HOBSONVILLE GROVE PRIVATE PLAN CHANGE

Stormwater Modelling and Flood Risk Assessment Report – RFI Response 2

Austino Property Group

TO:	Auckland Council	HG PROJECT NO:	A2212330.03
FROM:	Saeed Ghavidelfar, Fatemeh Mohammadi	DATE:	21 November 2024

Figure 2. Culverts set up and 2D mesh configuration in InfoWorks ICM model.

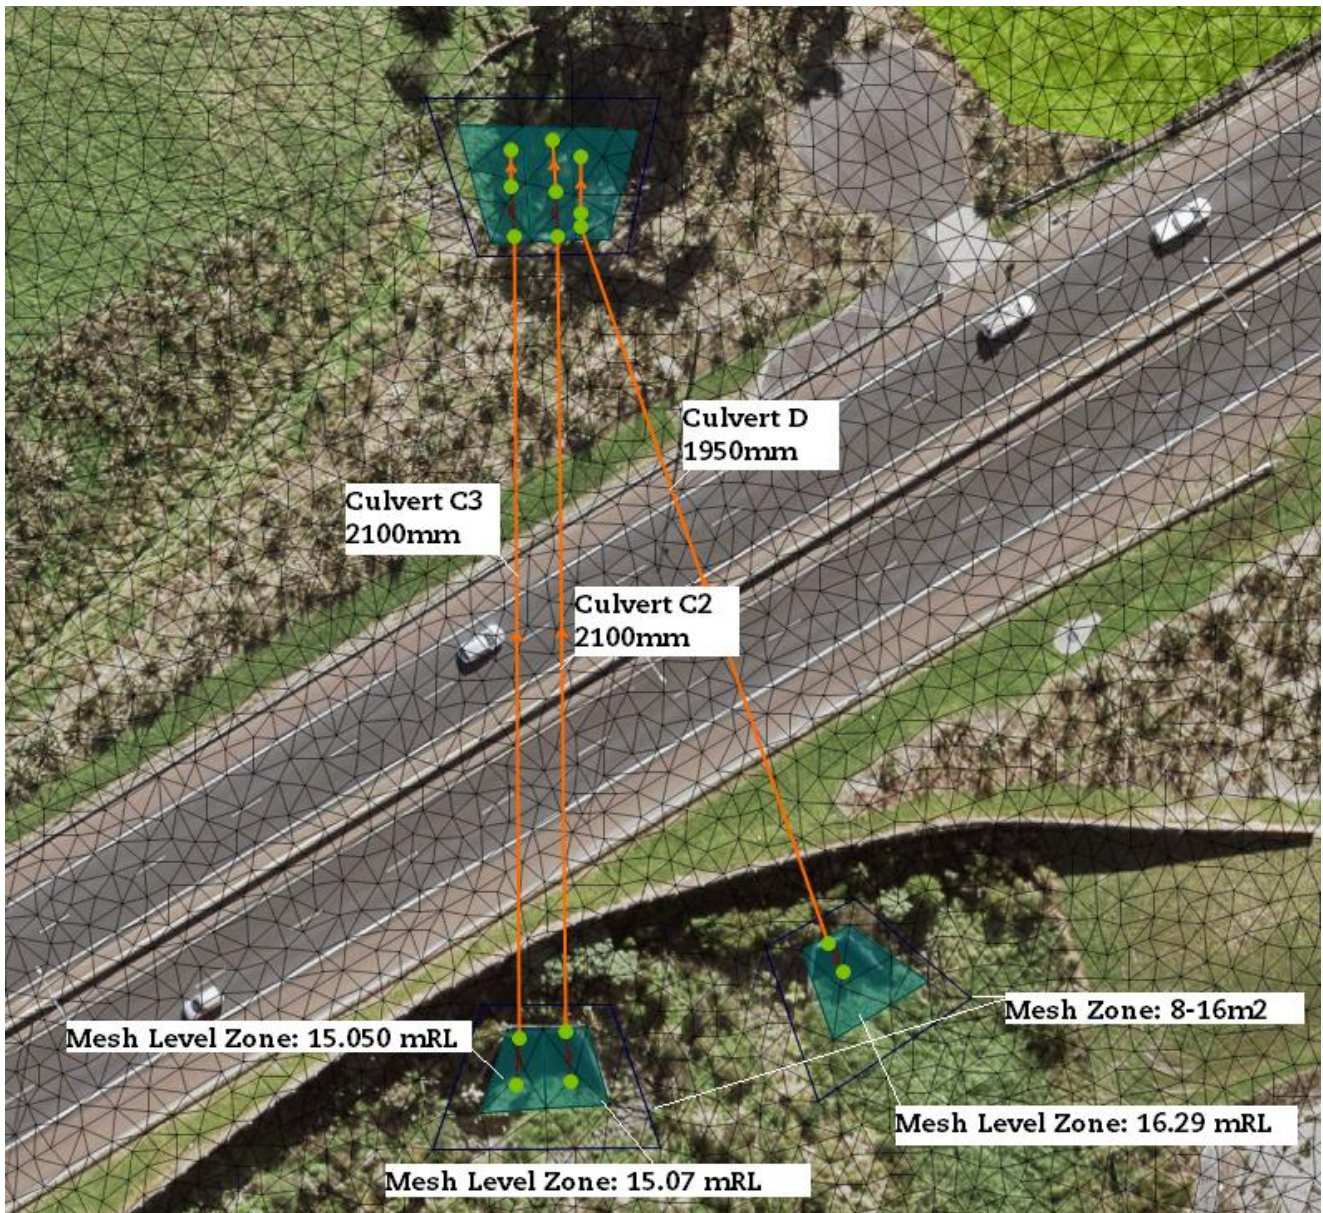
Please discuss why an increased 2D mesh size at the culvert inlet and outlet is used? It would be expected that there would be a higher resolution near culverts, not a lower resolution. This approach may have been used for model stability purposes (which is fine). However, such modifications are not "real" and it may cause some issues. Has the culvert performance been checked using manual checks or HY8 (for example) to make sure that the culvert flows are reasonable?

The flood depth maps (Figure 13 and 14) show flat, "dug out" sections near the culverts. It is recommended that the mesh size near the culvert is close to the culvert dimension and represents the channel near the culvert as best as possible (conveyance and storage). The current representation could be misrepresenting water levels upstream and downstream of the culvert, please clarify. As per the previous comment this approach may have been used for model stability reasons. Please confirm.

A higher mesh size (6-18m²) was assigned to the 2D Zone upstream and downstream of motorway culverts to avoid culvert 1D nodes having their flow limited from the 2D zone. Using large mesh sizes around the 1D culvert inlets/outlets along with increasing the number of 2D mesh connecting to the culvert nodes by increasing the "2D element area factor" is a standard modelling approach in InfoWorks ICM to produce accurate and stable results for the large culverts.

Due to high vegetation cover, the LiDAR levels around the culvert motorway's inlets and outlets are slightly higher than those in the survey data extracted from the URS model. Thus, Mesh Level Zones were added upstream and downstream of culverts to drop the ground levels to match the culvert invert levels. Modifying LiDAR was essential for a smooth flow transition between the 1D culvert and 2D surface, ensuring the model's stability and accuracy.

Figure 5. Flow directions around motorway culvert.

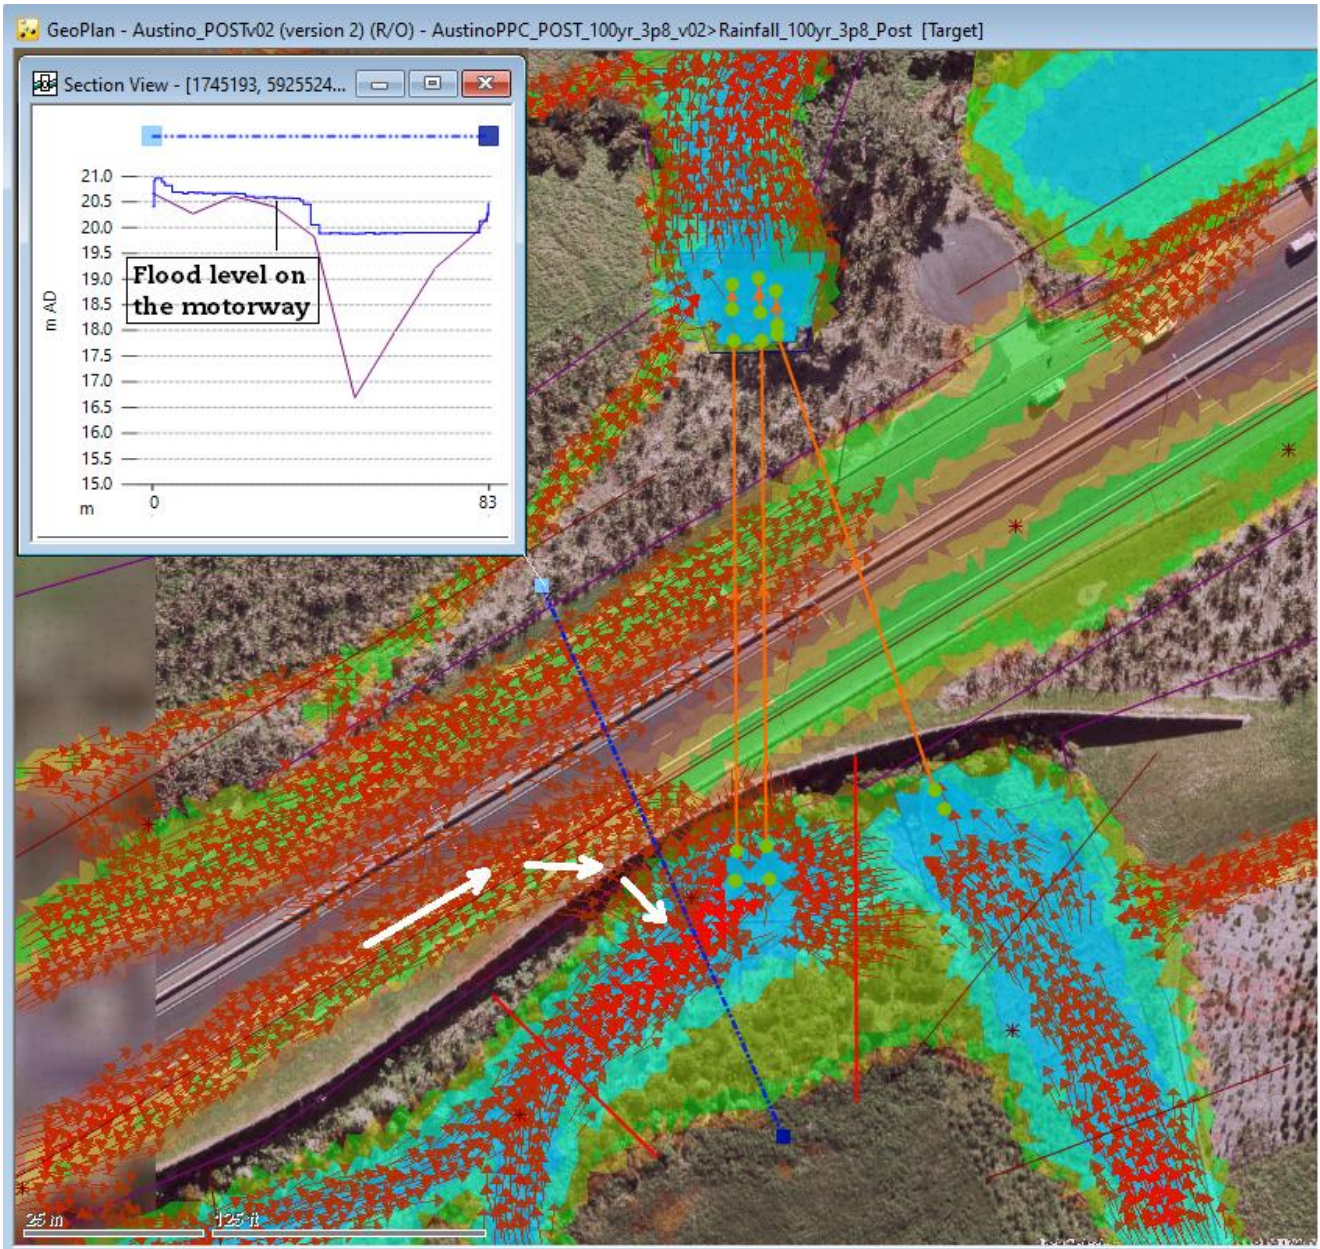
The model results show that the culvert doesn't overtop, however there is some ponding on the road, likely caused by the overland flow paths along the road (see Figure 14), please clarify.

Figure 5 shows the flow directions around the culvert's motorway for the post-development 100yr 3.8° storm event. The flood ponding on the motorway is generated by the local overland flow paths. The motorway flood discharges into the stream since its level is higher than the maximum flood level in the stream, as shown in the cross-section below.

Figure 7. Peak modelled water level difference, post minus pre 100yr no CC, 50% blockage of motorway culverts

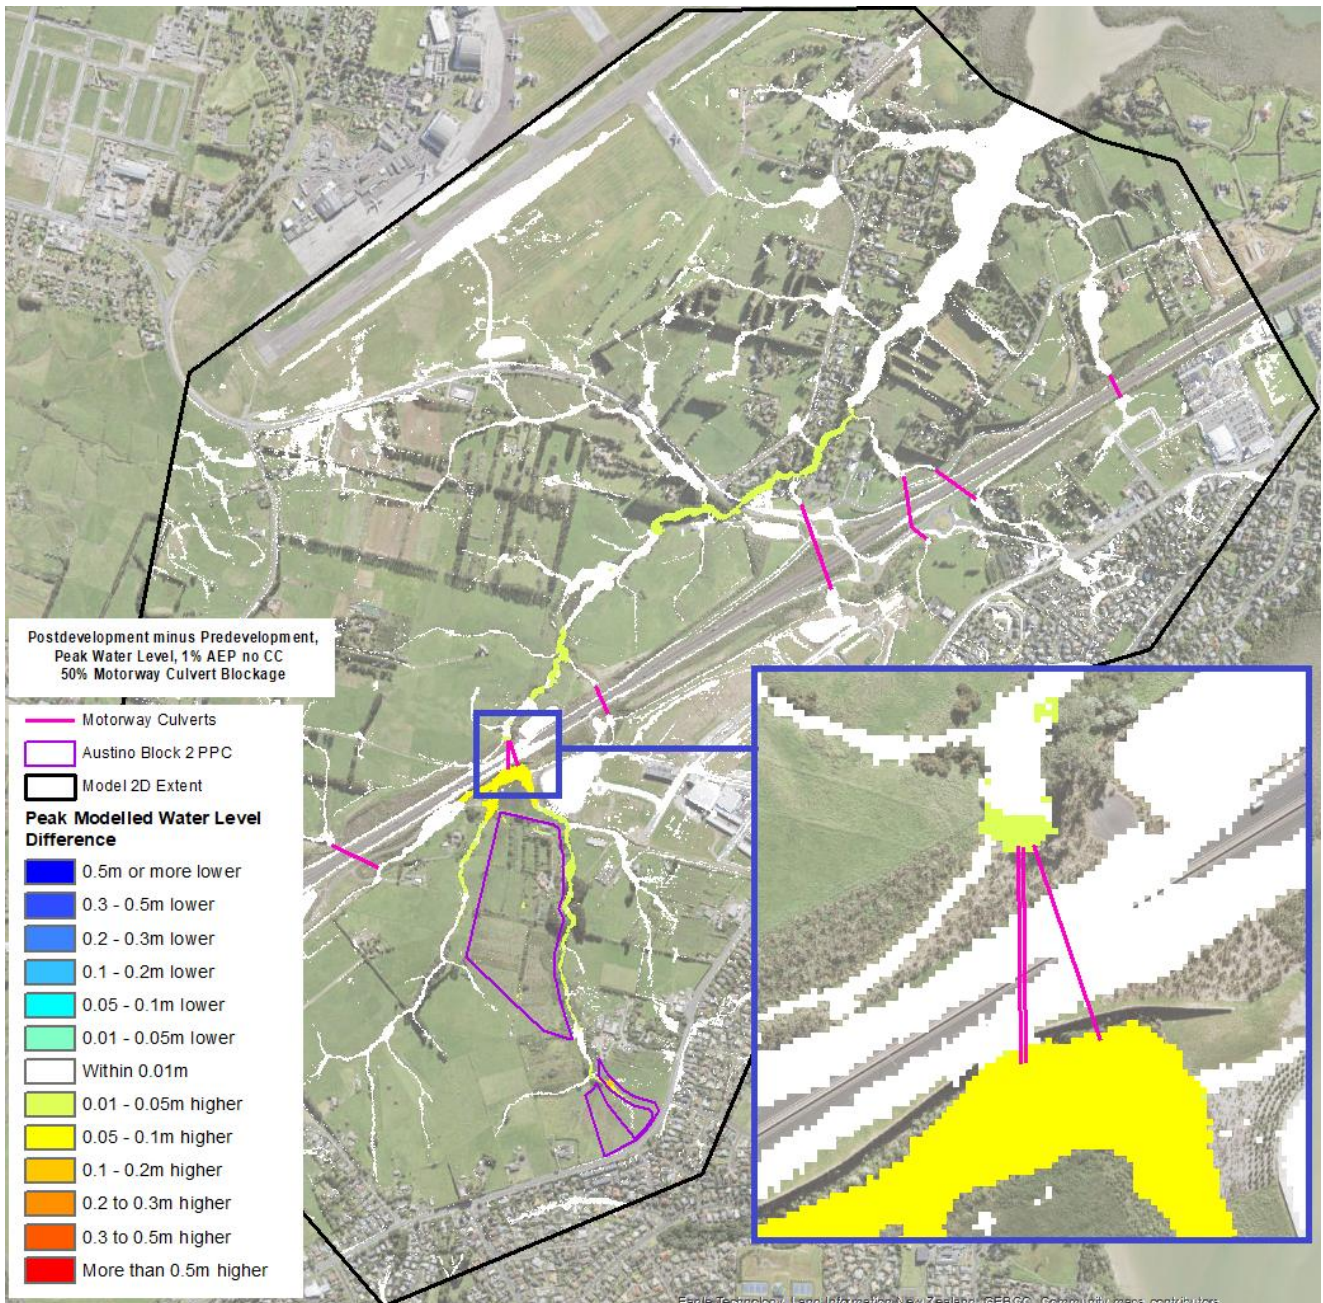
Please discuss why blockage scenarios do not seem to have been considered as part of the culvert capacity analyses, and what would be the effects of this on upstream properties and the motorway?

Figures 7 and 8 show the water level difference between post-development and pre-development for the 100-year 3.8°CC and no CC with a 50% culvert blockage scenario, respectively.

Under no climate change and with 50% blockage, the proposed development has no impact on the motorway since the flood does not overtop it (Figure 7 and Table 1). The motorway crest level is around 20.6 mRL.
